# UNITED STATES PATENT AND TRADEMARK OFFICE

APPLICATION NO.	FILING DATE	FIRST NAMED INVENTOR	ATTORNEY DOCKET NO.	CONFIRMATION NO.
09/864,389	05/25/2001	Jacob Richter	2390/49704	1194

# Office Action Summary

*Fig. 30*

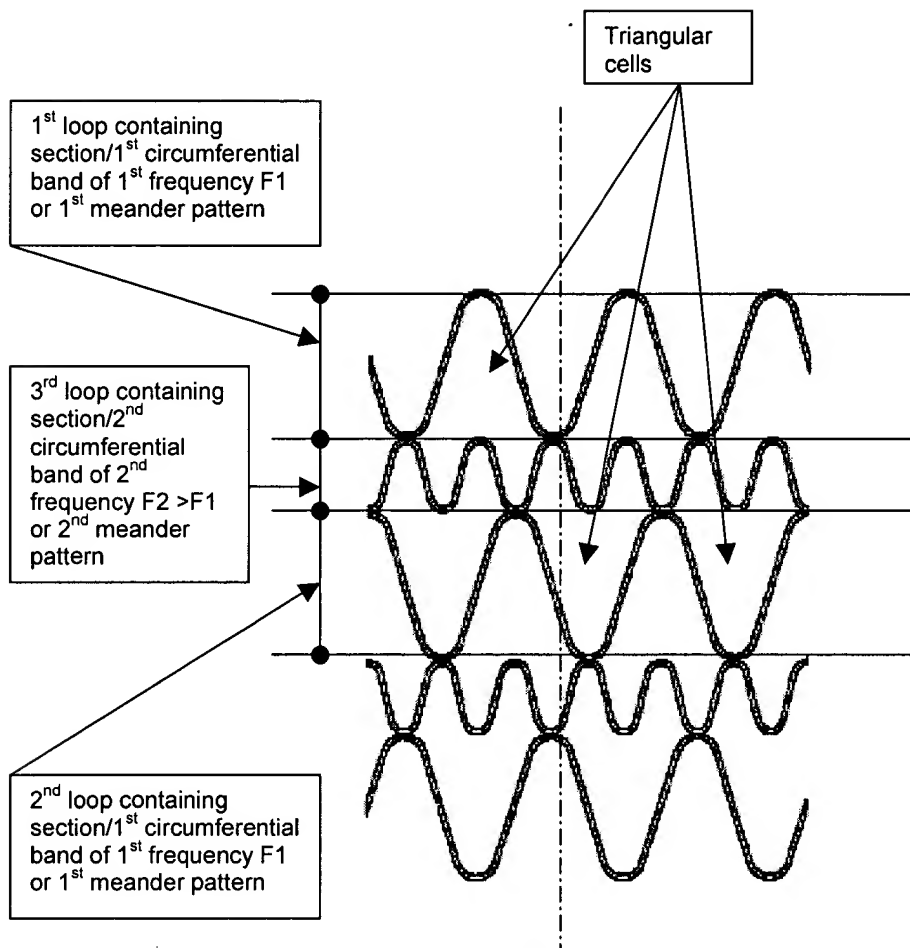
As to claims 1-2, 4, 6-7, 11-12, 14, 16-17, 19, 42-47, JAYARAMAN (see Fig. 30 on page 3 above) shows a stent structure comprising 1<sup>st</sup> and 2<sup>nd</sup> loop containing sections/1<sup>st</sup> circumferential bands/1<sup>st</sup> meander pattern of a 1<sup>st</sup> frequency F1, 3<sup>rd</sup> loop containing sections/2<sup>nd</sup> circumferential bands/2<sup>nd</sup> meander pattern of 2<sup>nd</sup> frequency F2 > F1 to define cells/triangular cells as recited in the claims.

a. 3<sup>rd</sup> loop containing sections are configured in a sinusoidal shape of a frequency F2 higher than a frequency F1 of 1<sup>st</sup> and 2<sup>nd</sup> loop containing sections (Fig. 30, page 3 above), therefore 3<sup>rd</sup> loop containing sections do expand or contract when the stent structure is bent/expanded, thus 3<sup>rd</sup> loop containing sections do contribute to the cells elongating or shortening when the stent is in a curved configuration/expanded configuration. In addition, because the 3<sup>rd</sup> loop containing sections have more stored length (or more springy/wavy than 1<sup>st</sup> and 2<sup>nd</sup> loop containing sections), the 3<sup>rd</sup> loop containing sections are more flexible and more sensitive to deformation than 1<sup>st</sup> and 2<sup>nd</sup> loop containing sections, therefore during flexing of the stent, 3<sup>rd</sup> loop containing sections contribute more to the stent deformation than 1<sup>st</sup> and 2<sup>nd</sup> loop containing sections.

b. Cells/triangular cells in one side of a neutral axis of bending of the JAYARAMAN stent will be in a tension condition and in the other side of the neutral axis will be in a compression condition. Cells under the tension condition

will open in length and narrow circumferentially and cells under the compression condition will shorten in length but widen circumferentially.

A cell in Fig. 5, BERRY et al.

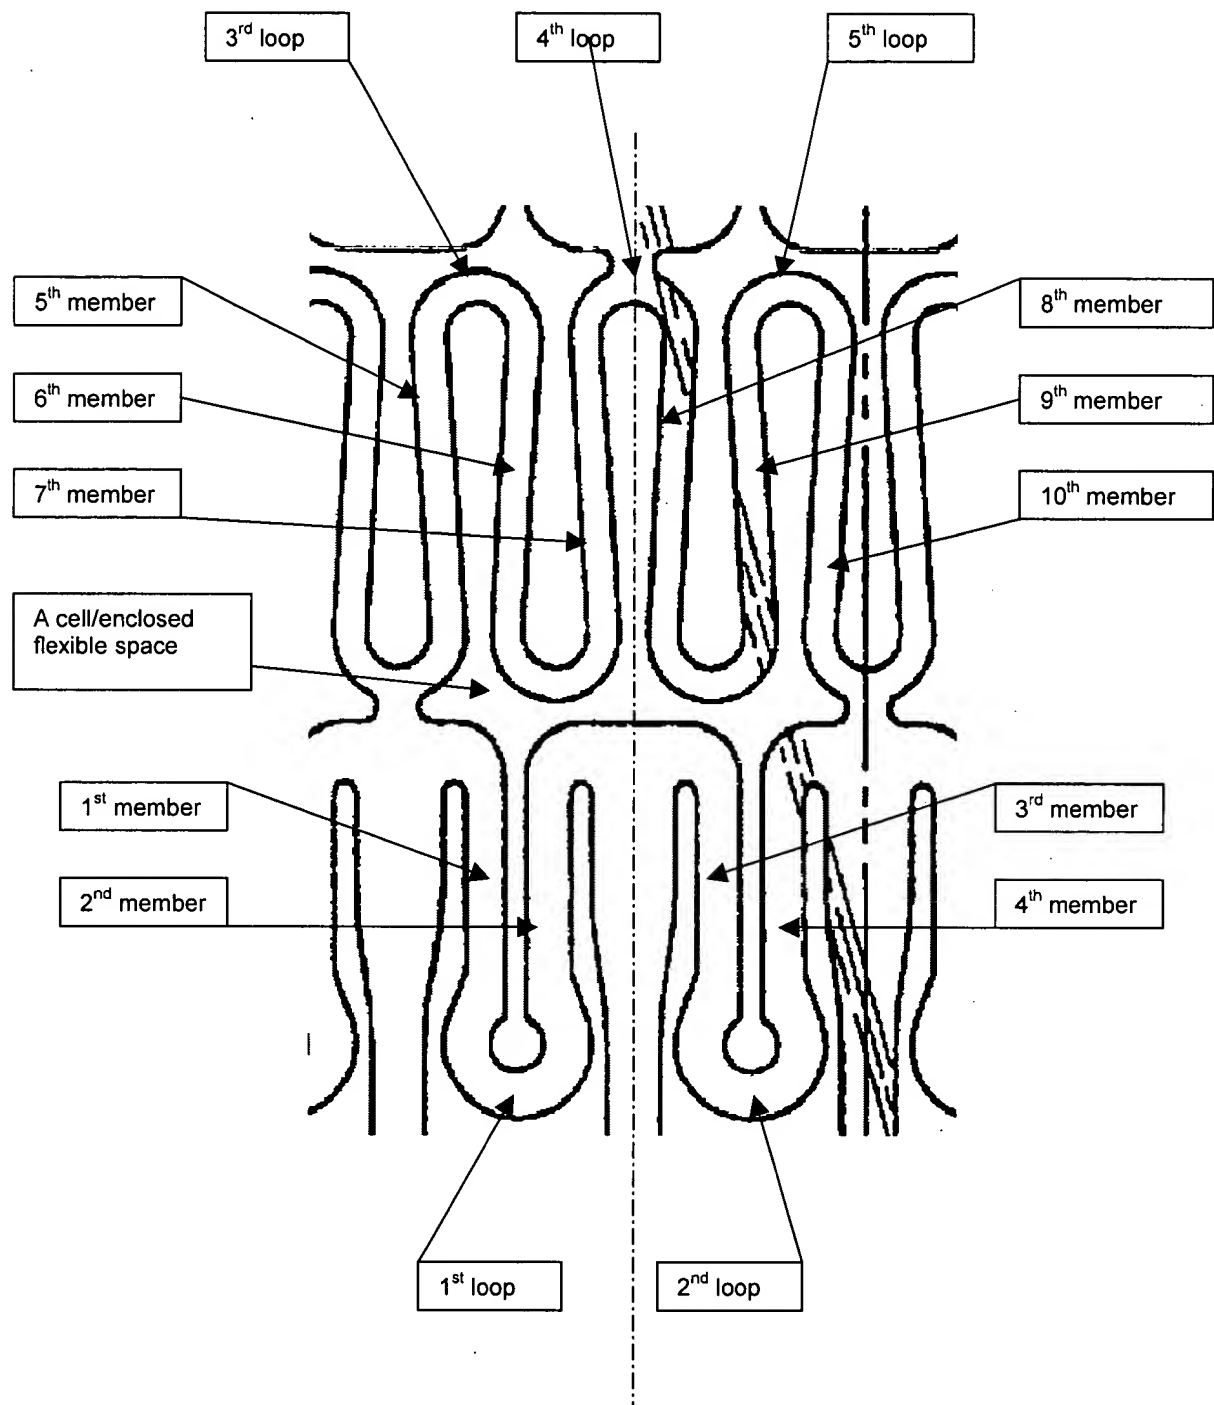
As to claim 26, BERRY (see BERRY Fig. 5 and BERRY triangular cell in page 4, this paper). Notice that BERRY stent comprises many flexible triangular cells to form a uniform mesh of flexible cells. Each BERRY triangular cell has a central axis BB. When expanded in a curved vessel, BERRY triangular cell will increase in length in one side of the neutral axis and decrease in length in one side of the neutral axis as recited in the claim.

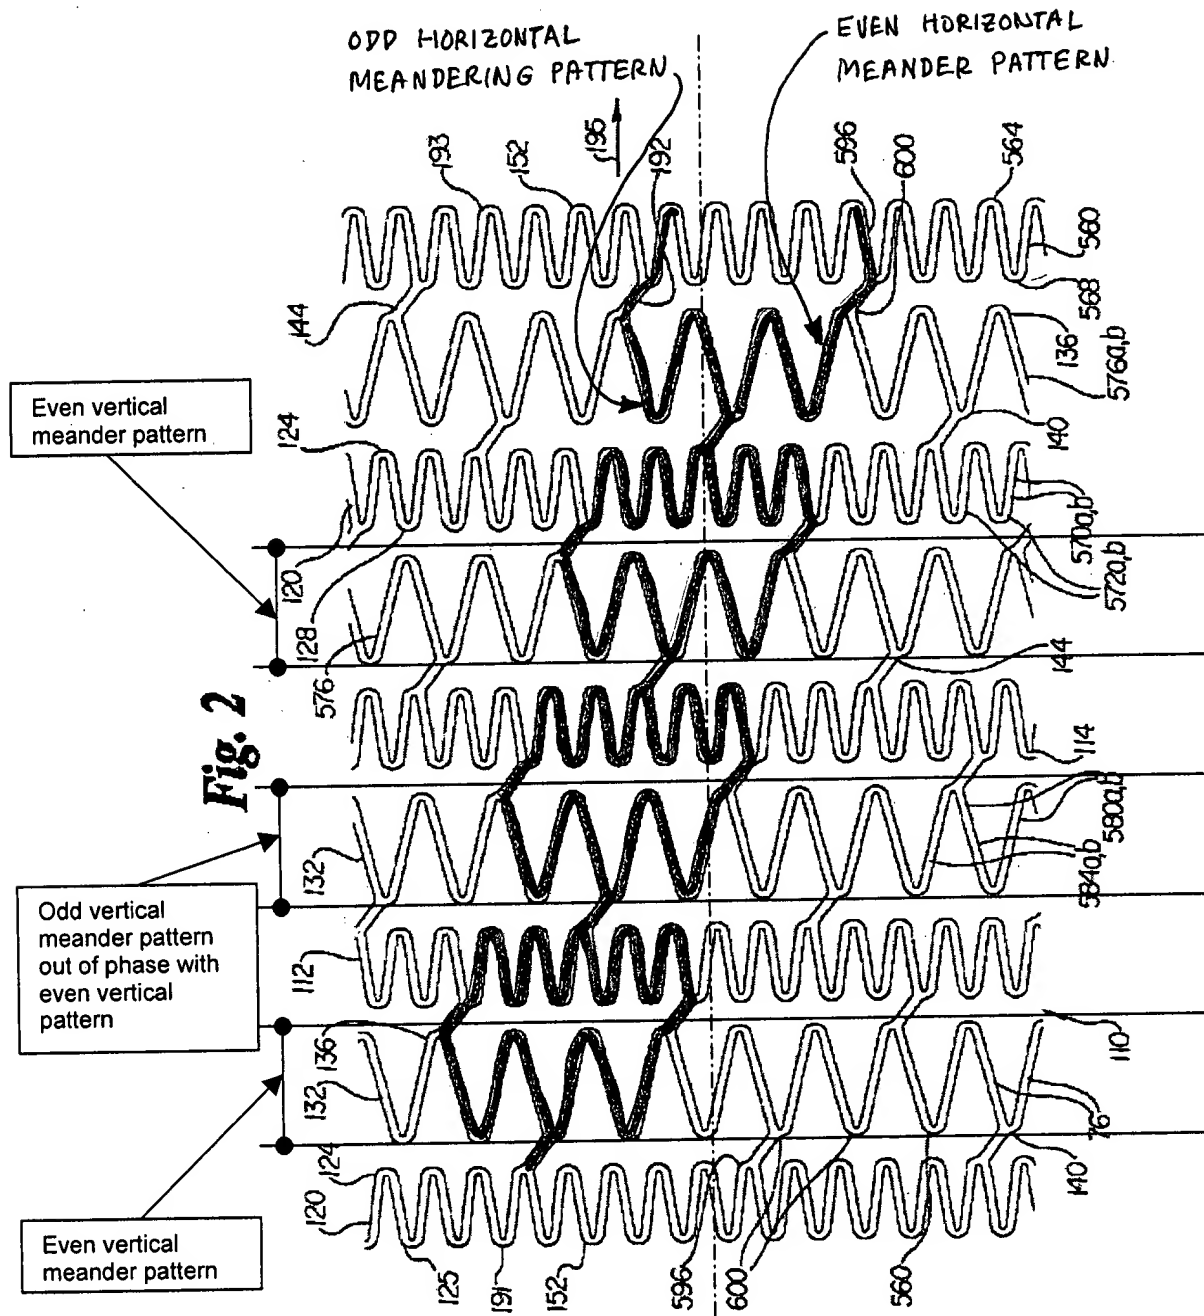
As to claims 21-22, 24, 48-49, BROWN (Fig. 2, page 5, this paper) shows even 1<sup>st</sup> meander patterns substantially are 180 degree out of phase with odd 1<sup>st</sup> meander patterns. Even 1<sup>st</sup> and odd 1<sup>st</sup> meander patterns alternate with and are spaced from each other to form a uniform flexible structure as recited in the claims. When expanded in a curved vessel, BROWN shows cells that increase in length in one side of a neutral axis/bending axis and cells that decrease in length in another side of the neutral axis.
